TRUCK, HEAVY, MC3 (MACK) ALL TYPES  
FUEL TANK SUPPORT BRACKETS

MODIFICATION INSTRUCTION

FIG 1 - REPAIR DETAIL

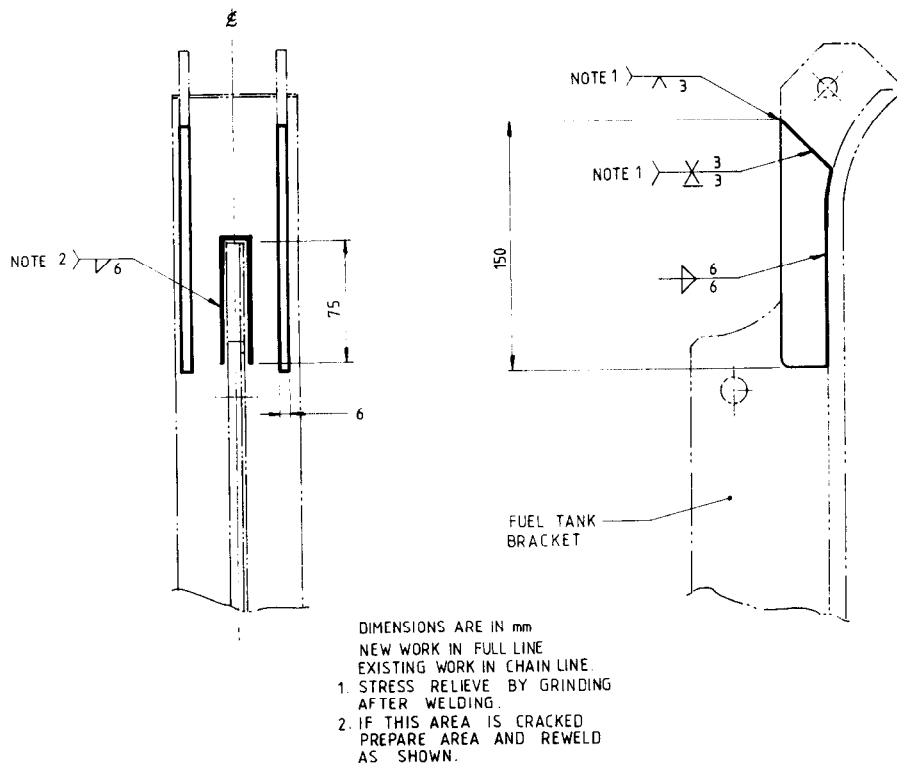
7. Stores Removed. Nil.
8. Detail. To carry out the modification, proceed as follows:
  - a. Drain the fuel from the fuel tank and remove the fuel tank and support brackets.
  - b. Gouge and reweld any cracked welds ensuring that the weld continues 75 mm down the supporting rib as shown in Fig 1.
  - c. Cut the steel bar item 1 Table 1 to the dimensions shown in Fig 1.

- d. Prepare the areas to be welded and weld using the electrodes, item 2 and 3 Table 1, as shown in Fig 1.
- e. To enable the modified bracket to be fitted to the cargo and cargo crane variants, the body mounting angle must be relieved by grinding four slots 6 mm wide and 15 mm deep where the additional strengthening ribs are located.
- f. Paint the reworked areas in accordance with WKSP B 700.
- g. Refit the fuel tank support brackets and fuel tank to the vehicle.
